Subject: Oconee Nuclear Station  
Docket Nos. 50-269, -270, -287  
Response to Request for Additional Information on  
the Oconee Emergency Power System

REQUEST FOR ADDITIONAL INFORMATION  
OCONEE EMERGENCY ELECTRICAL POWER  
DISTRIBUTION SYSTEM

<1> Test: Oconee 3 3LP017 1-4-97 4:36p 130.5 4 ES

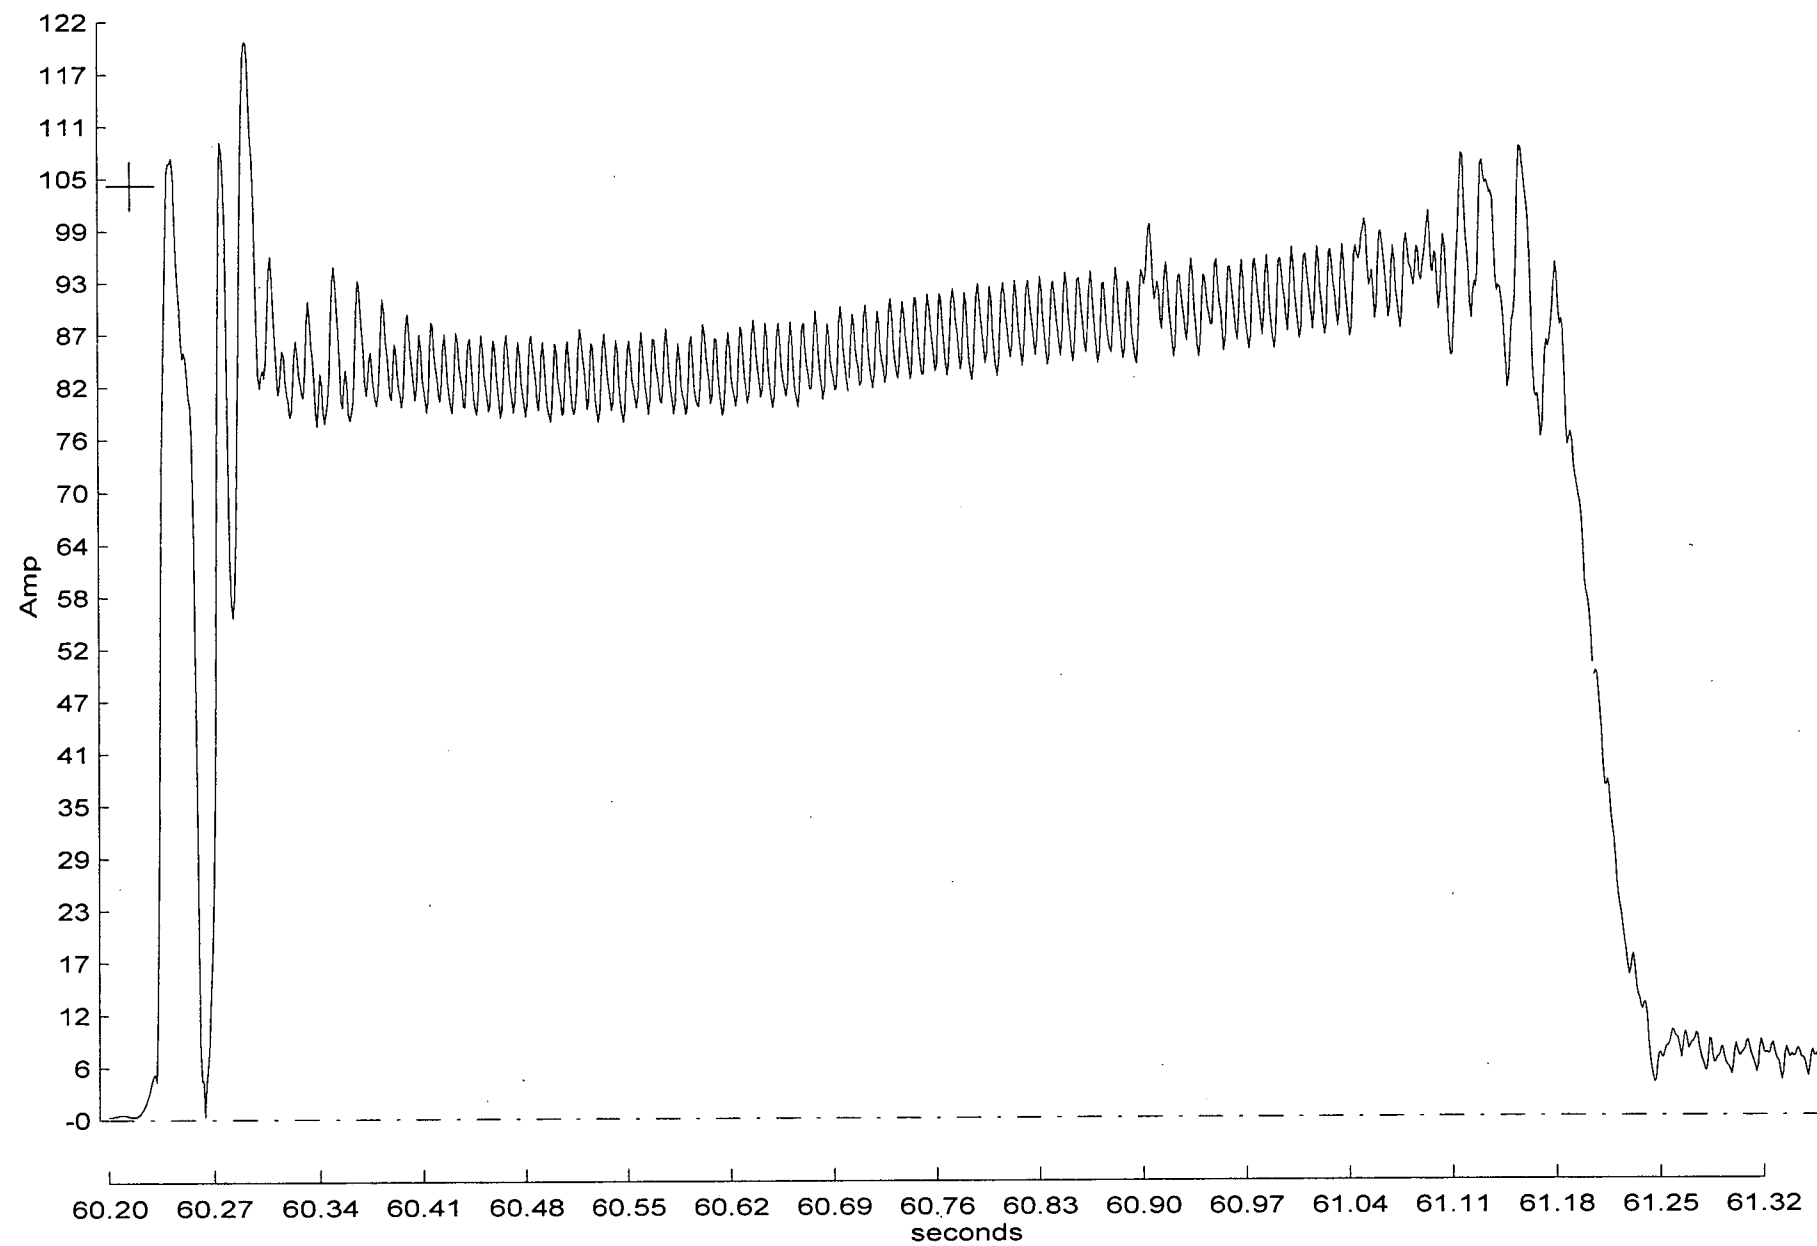
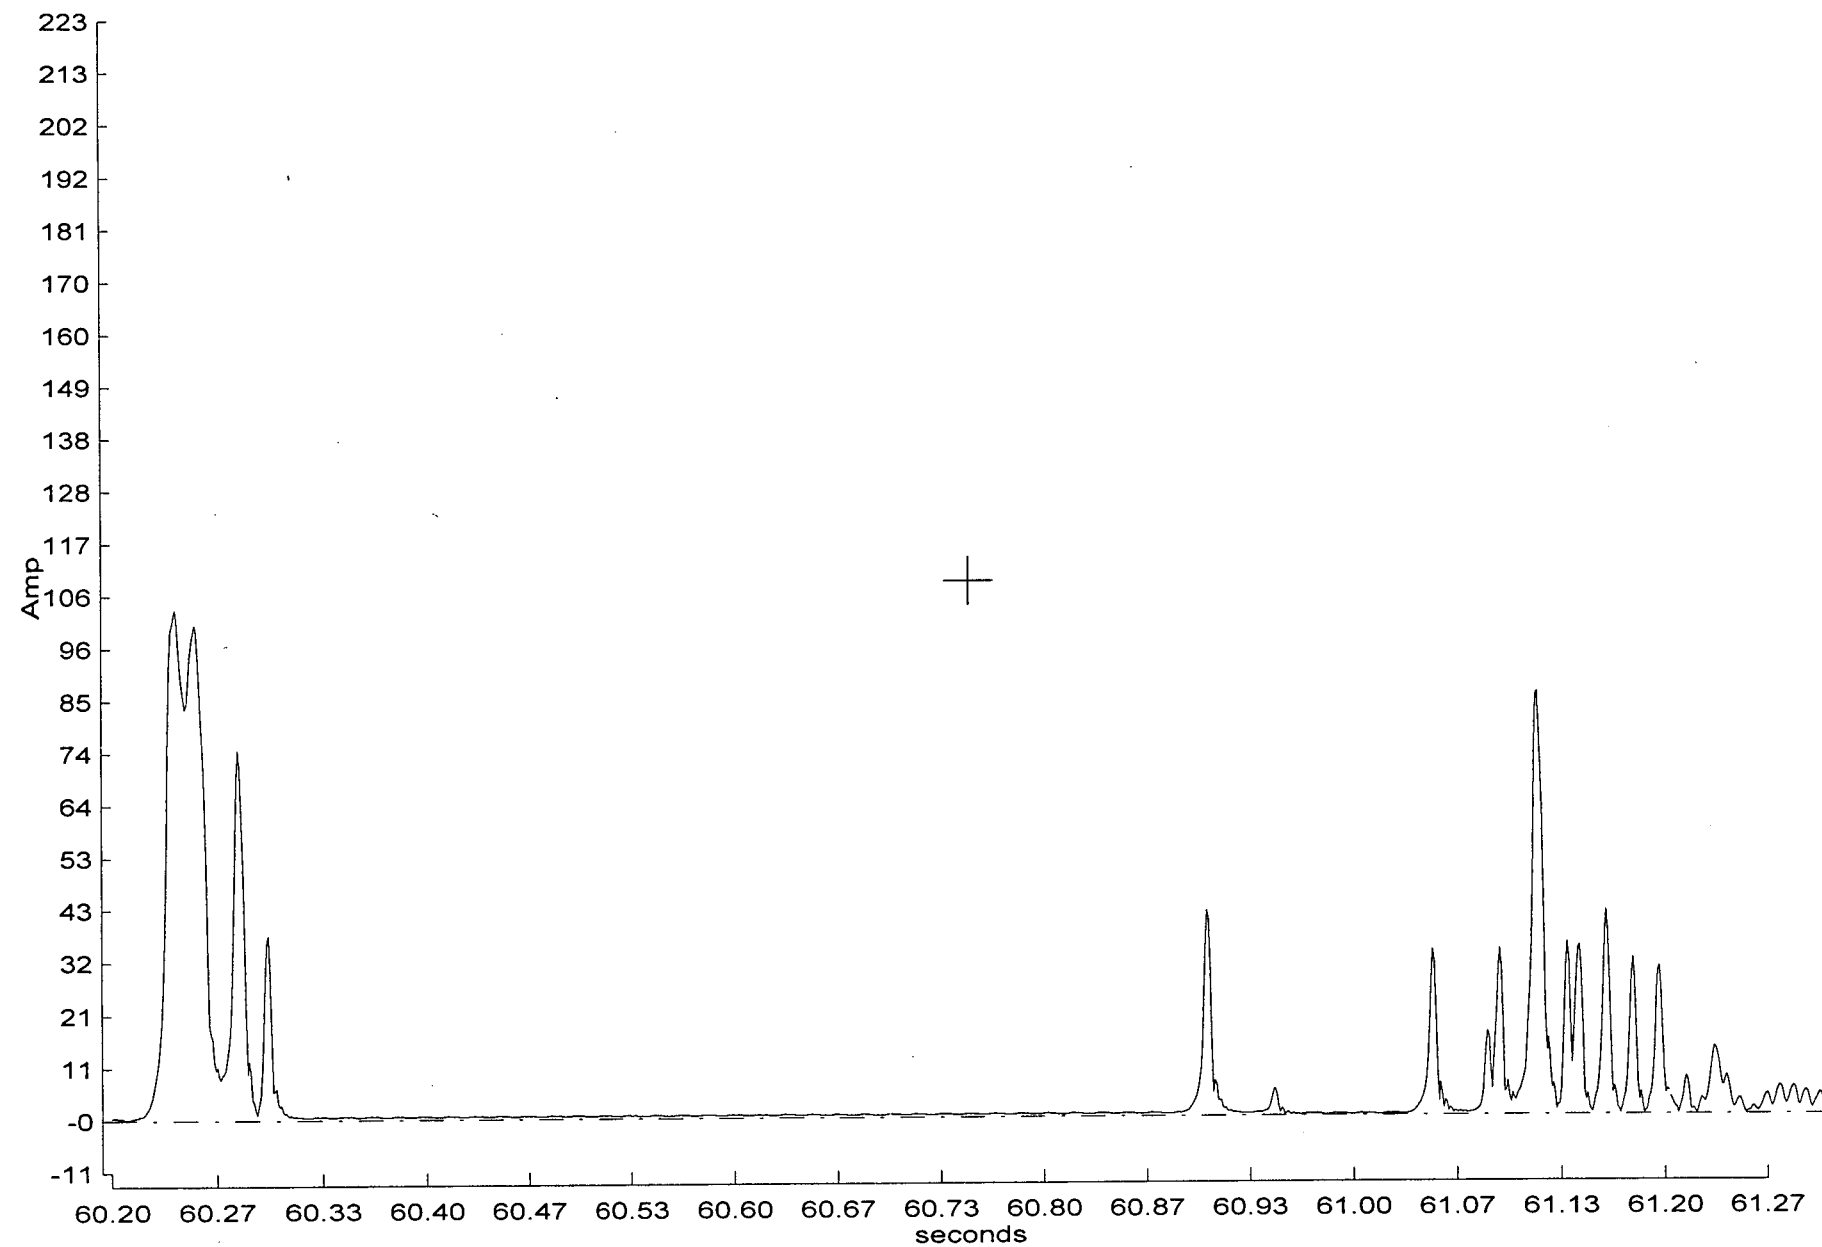
7. Section 5.2.4 of the report states that MOV 3LP-17, which is a gate valve, briefly stalled while starting following contactor pickup during Tests 4, 5, and 6. The stall times were 1.0, 1.0, and 0.4 seconds, respectively, for the three tests. The report indicates that the valve recovered in each case and completed its stroke to its proper ES position; and following inrush, valve stroke was normal and normal hammer-blow and unwedging was observed. We note that in all the LOCA tests where the MOVs are actuated, this particular valve's motor contactor picks up at a voltage value that is quite often one of the largest values seen on the group of valves that are monitored. On that basis, not considering any other variables, it would be expected that this valve would be the least likely to stall.

- d. Please provide plots of the valve motor's thermal capability and overload protection, overlaid on the starting inrush current figures shown for this valve during the tests.

monitored phases was analyzed for inclusion in the report since all valve stroke events could be identified regardless of which phase was analyzed. A more detailed review of the data for all three monitored phases indicates that the primary reason 3LP-17 appeared to stall was that the 'c' phase starter contact chattered while the 'a' and 'b' phase contacts maintained a stable energized state. Therefore, the 'a' and 'b' phases (one of which was included in the report) indicated stall conditions until the 'c' phase contact maintained a stable energized state. Once all three phases were energized, 3LP-17 stroked as expected. In retrospect, 3LP-17 did not actually stall as originally thought. Attachment 6 contains the plots of the current data for 3LP-17 which indicate the chattering of the 'c' phase contact.

Copies of the requested plots are contained in Attachments 2 through 6.
